Centre Plan Package A | Feedback Past Deadline Submissions

(Post May 8, 2018)

Centre Plan Review

Modelling select lots using draft Centre Plan Provisions

Squiggle Park

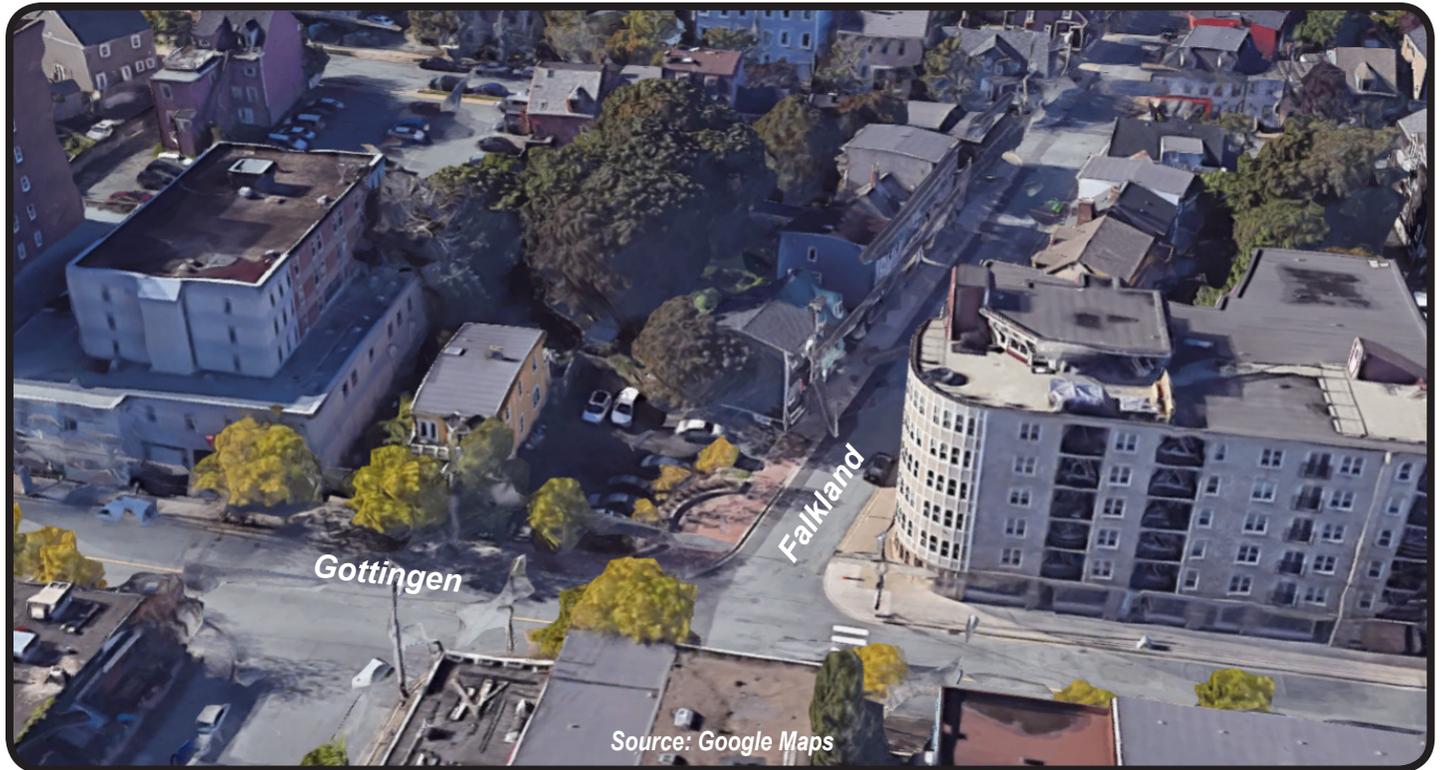
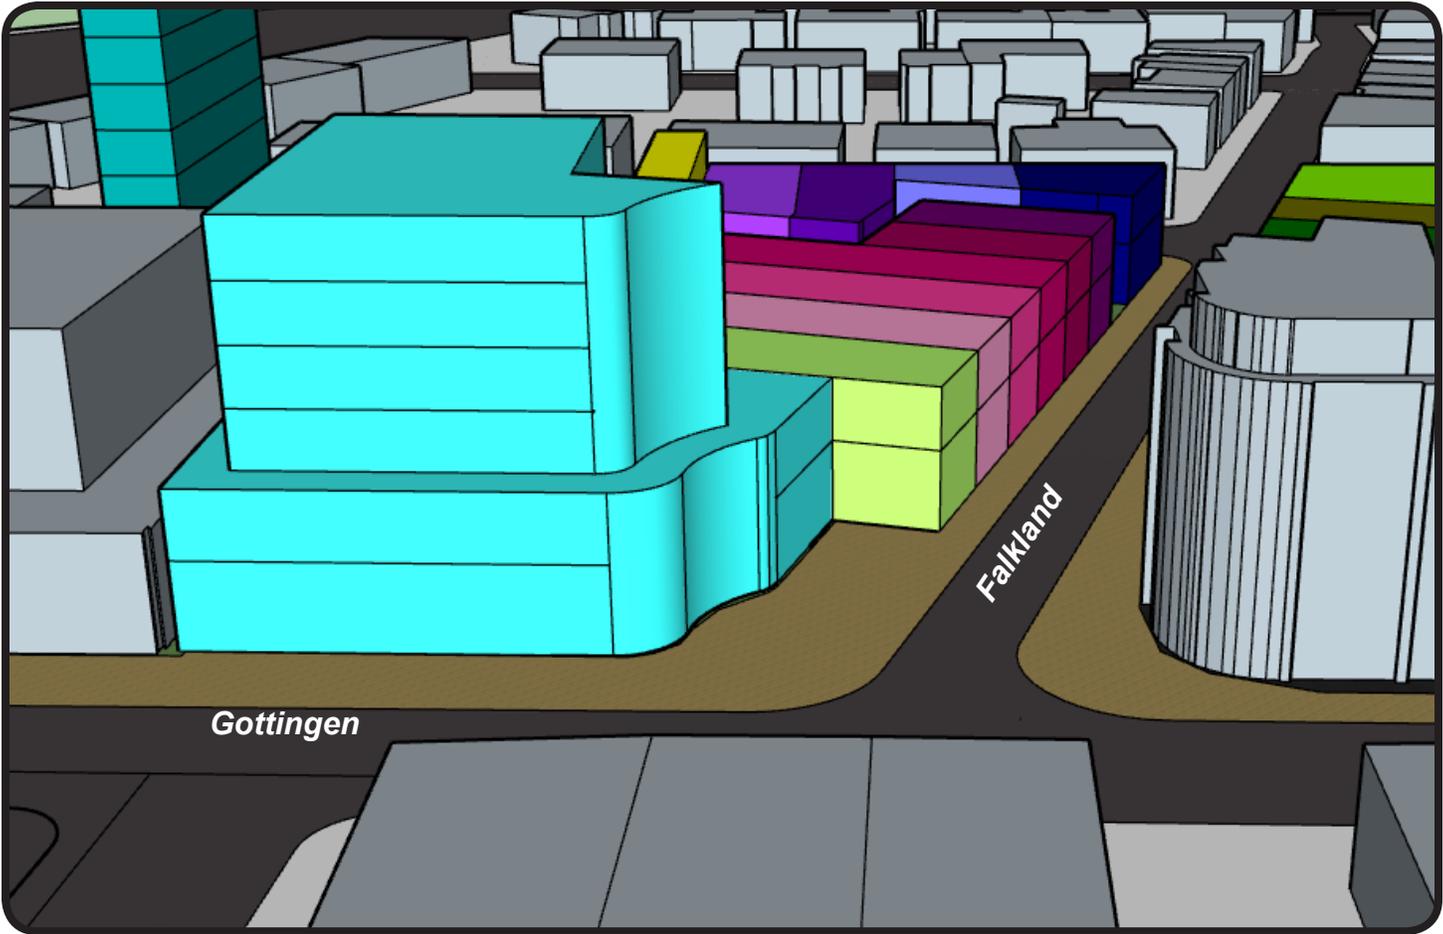
The lots on the corner of Gottingen and Falkland (including Squiggle Park) have been zoned to allow for the construction of a six-storey building. The concern on this site is that the building would be abutting two-storey homes. Since the corner lots are zoned CEN-2 and the Falkland St homes are zoned CEN-1, 100% lot coverage is permitted, meaning the six-storey building could be built right up to the lot line of the homes.

Falkland Street (south side)

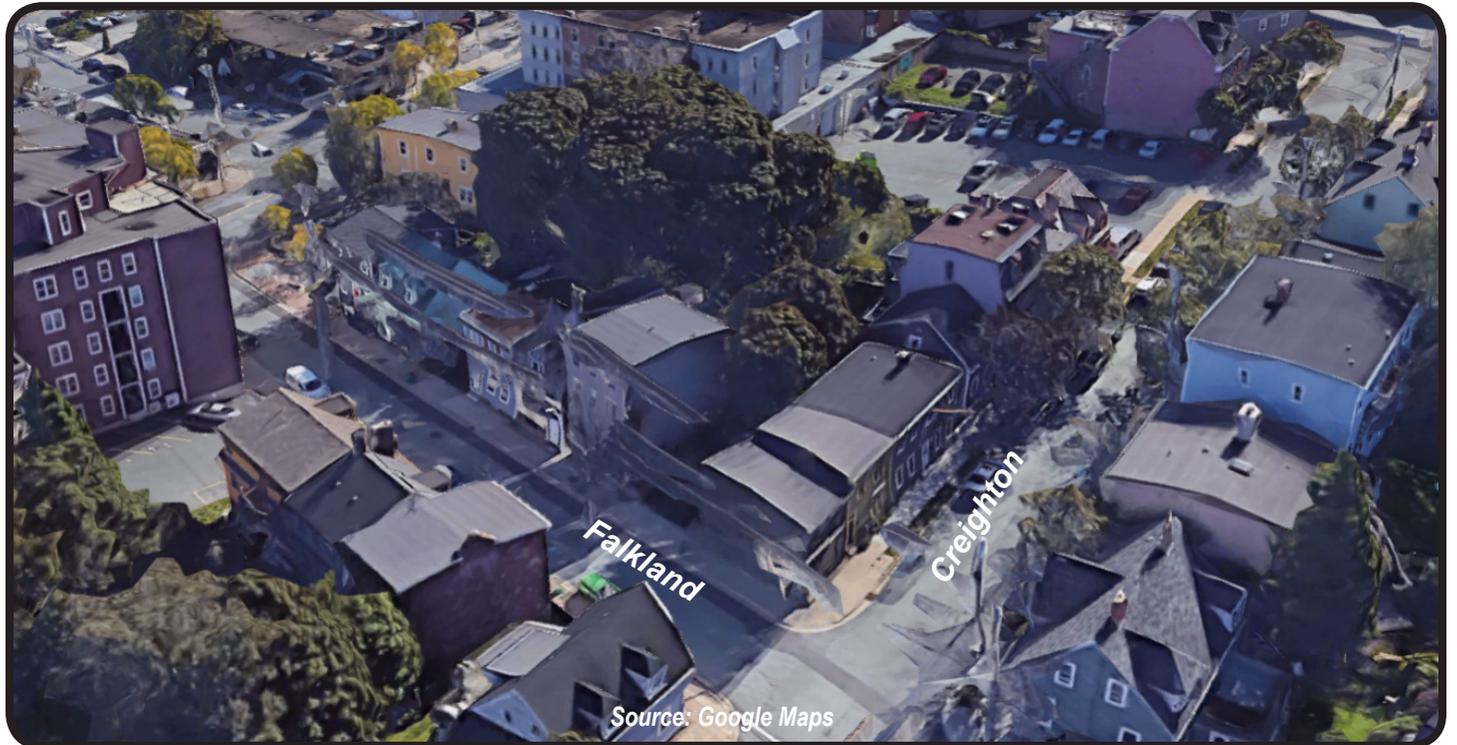
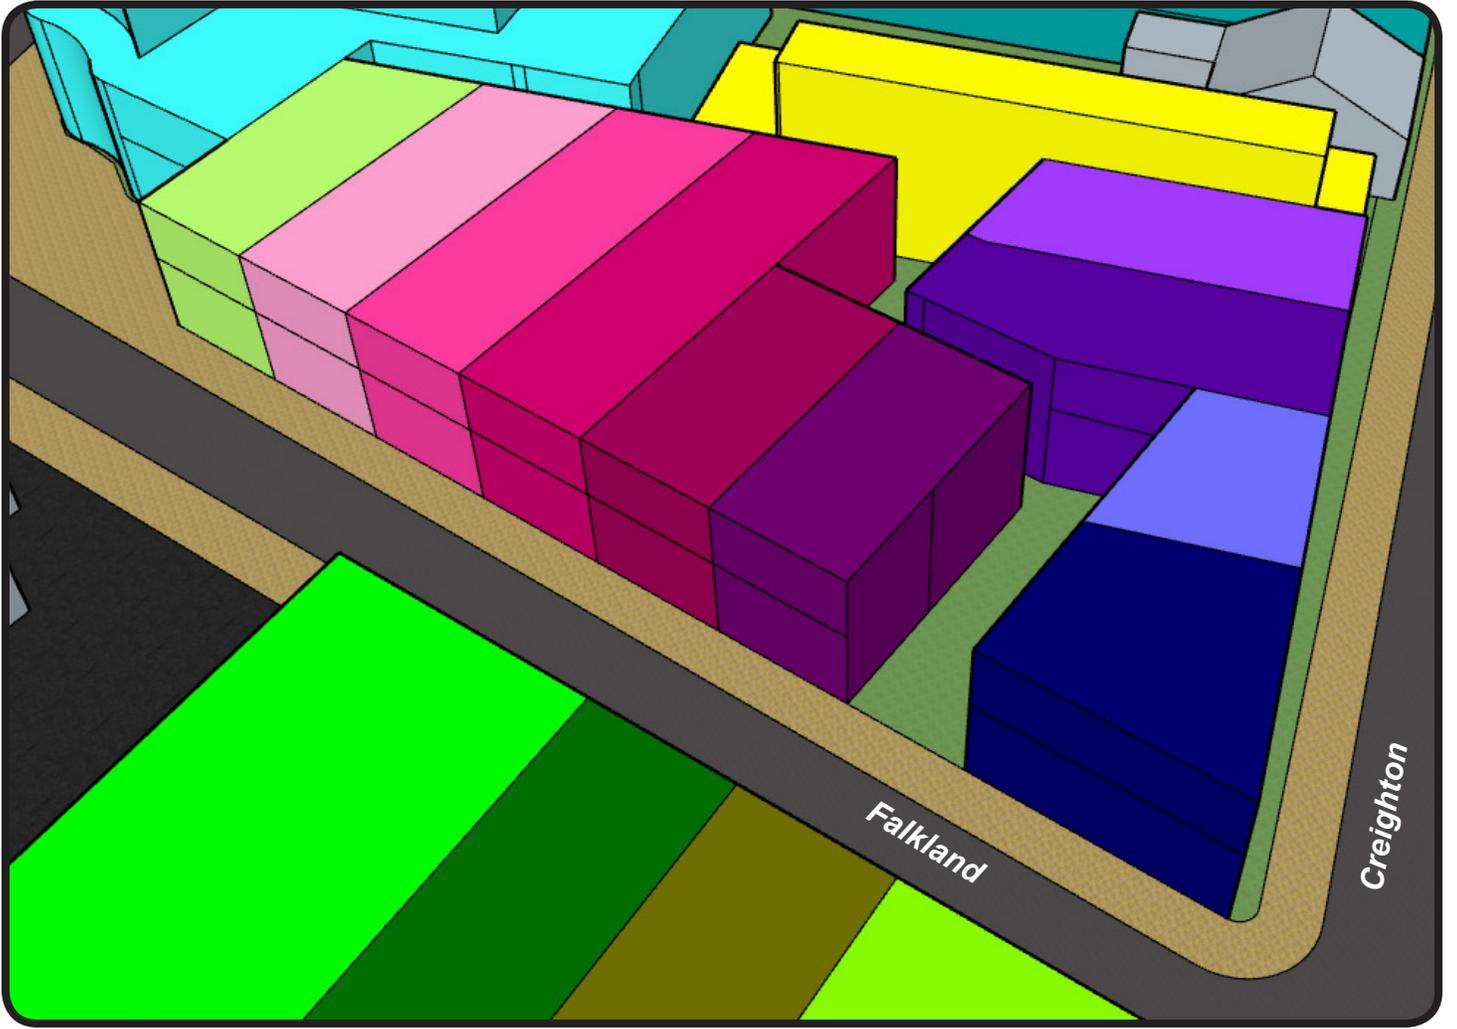
The initial concern with this block was that the consistent character of two-storey homes would be lost due to consolidation of lots to build larger buildings.

However, it would appear that the proposed zoning will encourage the retention of the older homes due to provisions allowing for similar sized structures as currently exist.

In the model, the zoning provisions allow for 100% lot coverage, however once the GFAR was applied to the buildings, it made more sense to have identical first and second floors.

Falkland Street (north side)

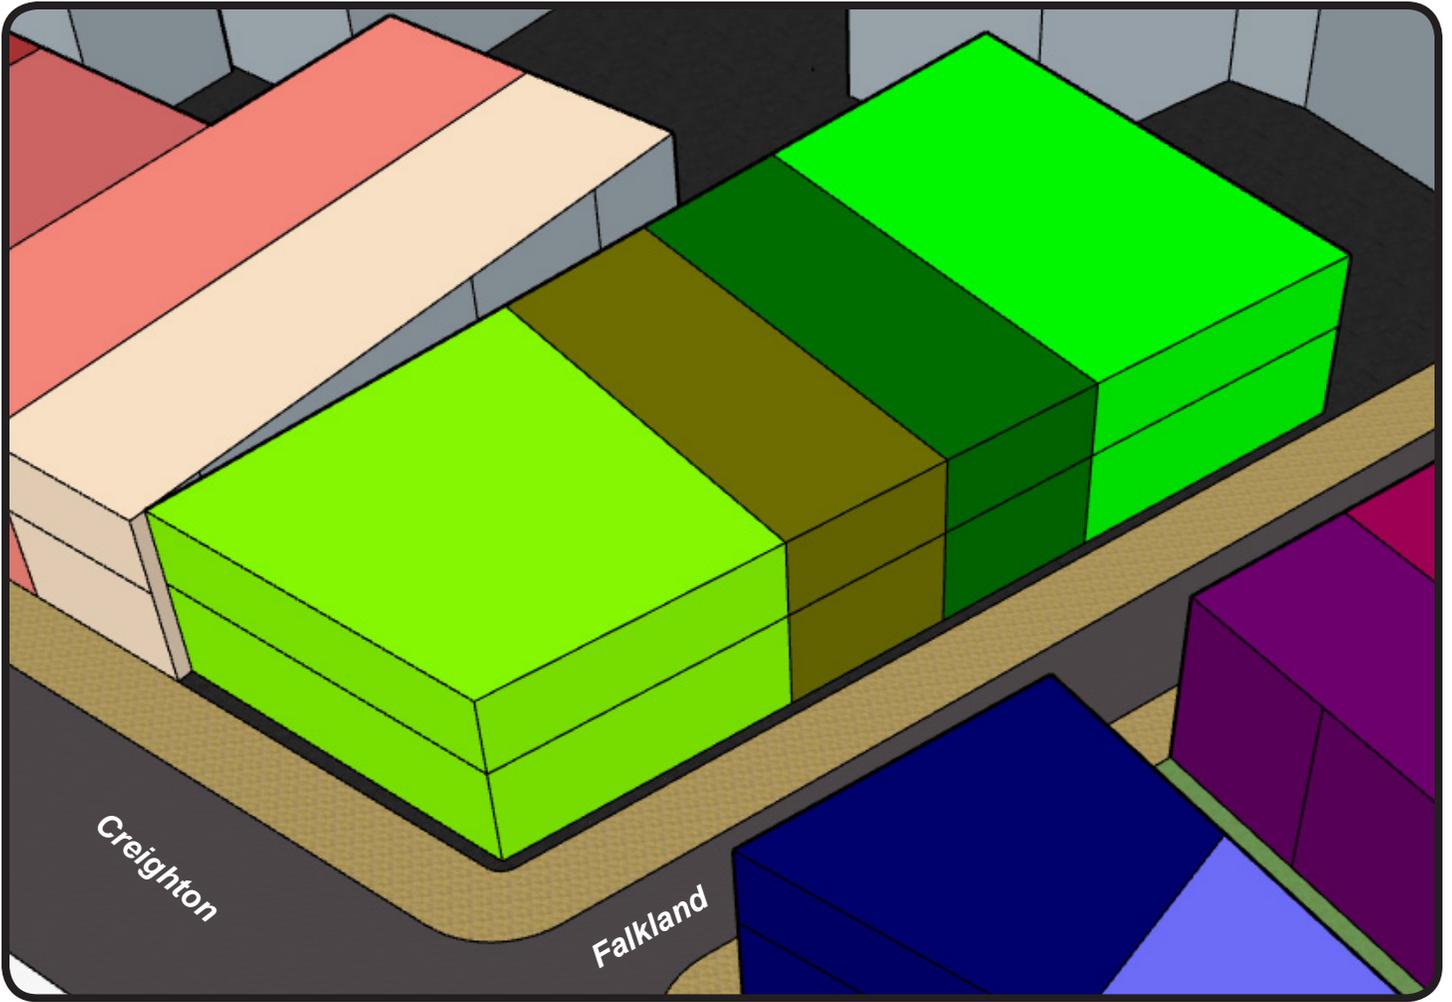
This side of the street had the same concerns as the south side (see page 4).

Another concern that was raised for this street was the provision requiring buildings with 4 units or less to accommodate parking, while buildings with over 4 units would not require parking. This could easily make it more appealing to consolidate lots and develop a larger building to avoid the parking requirement. In discussions with HRM planning staff, it would appear that this provision will be changed and remove all parking requirements from CEN-1 and CEN-2 zones.

2019 Creighton

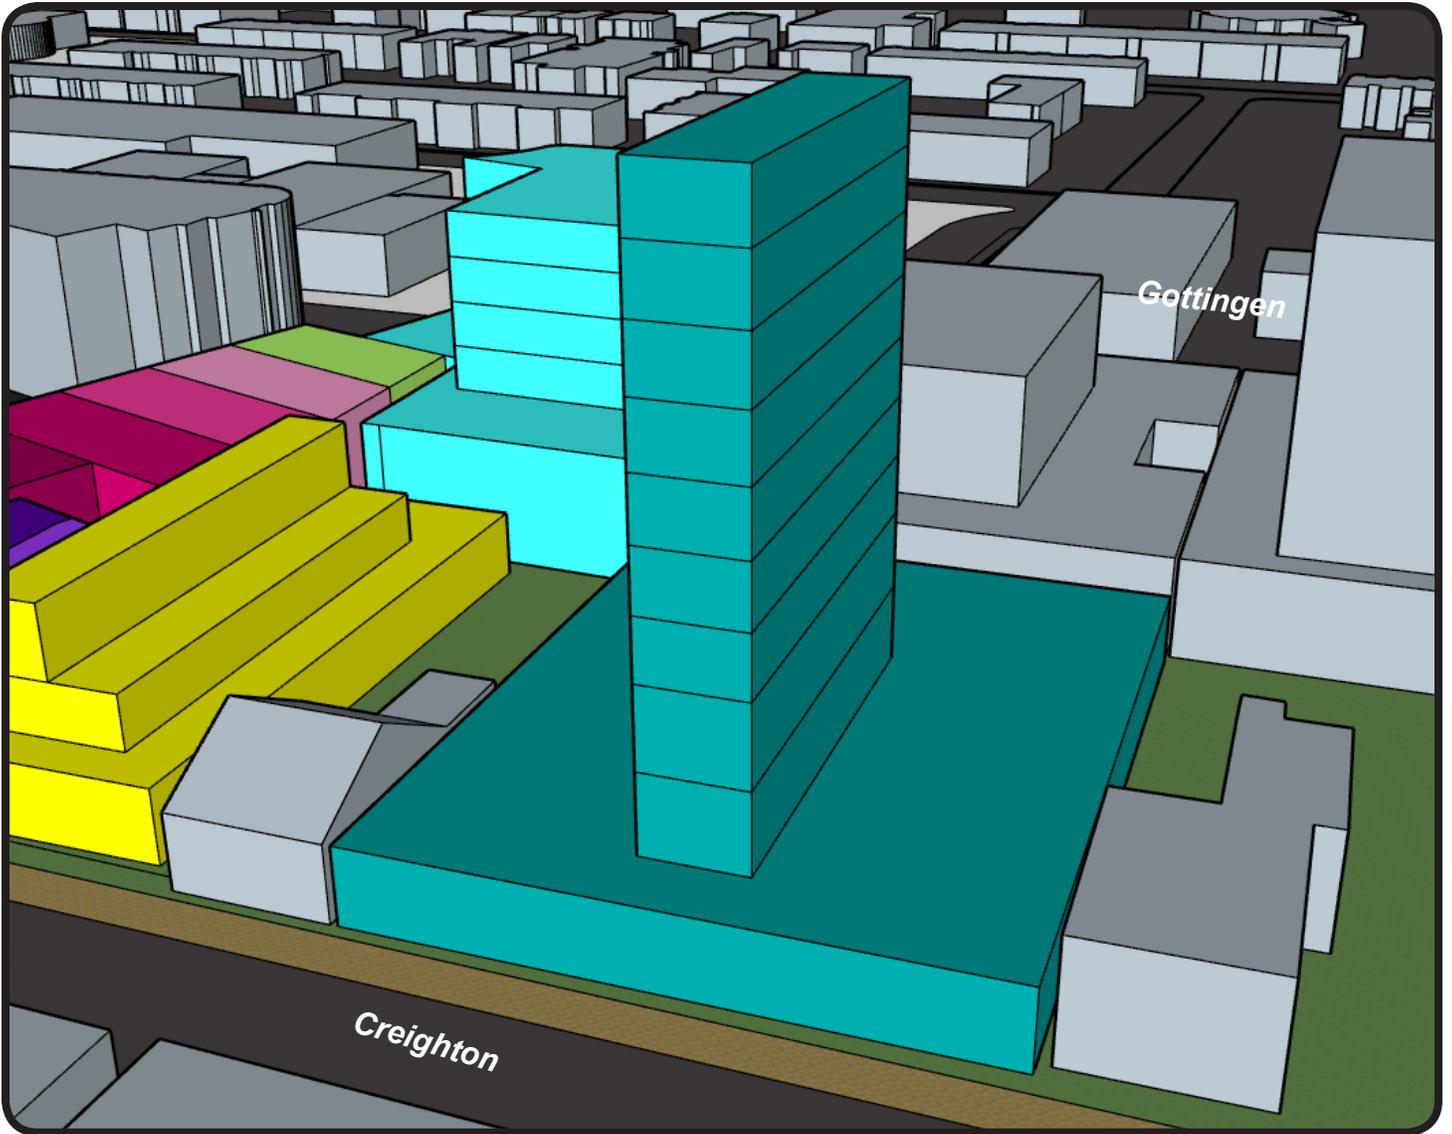
The main concern for this site was the fact that the new provisions allow for a 10-storey building to be constructed next to a 1.5 storey heritage property.

Upon further evaluation, it would not be viable to build a tower on this site. The permitted GFAR for the site is 5.00. However, when applying the land-use provisions, the resulting GFAR for the largest possible building is only 1.84.

The provision resulting in narrow tower would be the interior lot line setbacks of 12.5m. This provision is meant to have a buffer of 25m between towers. Although this provision's intention is to maintain high quality of living in towers, a high-rise building on this site is simply not achievable.

The analysis of the site begs the question why would the lot be zoned for this height when it would be impossible to build to that height. A model of a building envelope applying mid-rise building provisions was done to explore other options for this site. Please see page 33 for a complete breakdown of the number for the high-rise and mid-rise options.

Creighton Street (between Falkland and Cornwallis)

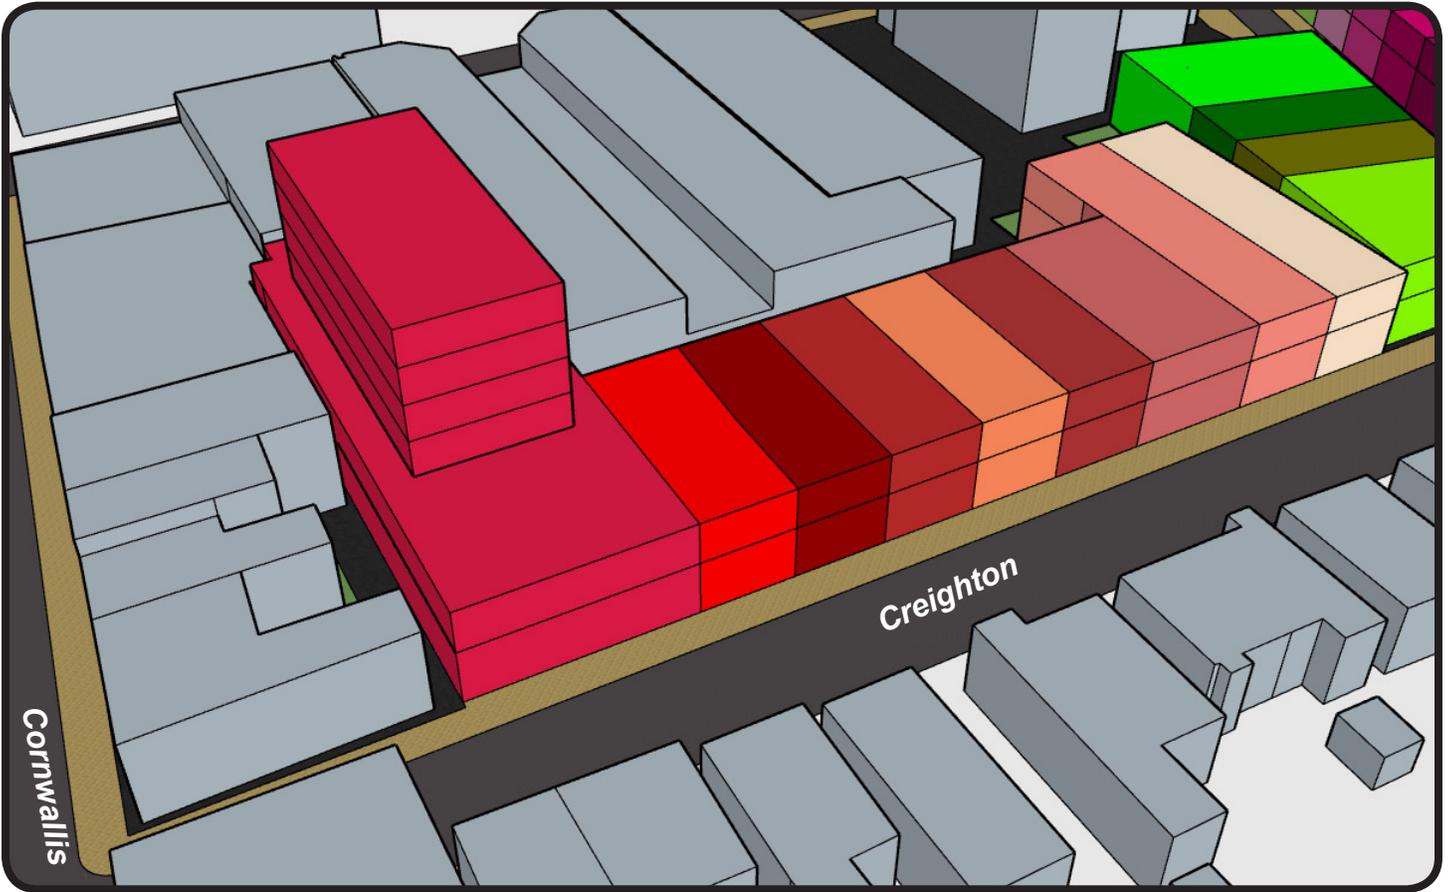
Similar to Falkland, one of the concerns for this street was the threat to the existing character. Also like Falkland, the new LUB provisions have a maximum height of 11m and a relatively low GFAR of 1.75. This will encourage existing homes to be retained and renovated.

There is only one lot on this side of the street that is zoned for 20m maximum height, and based on the existing lot arrangements, the portion of the building above the podium would likely be placed in the rear of the lot, and not interfere with the character of the street.
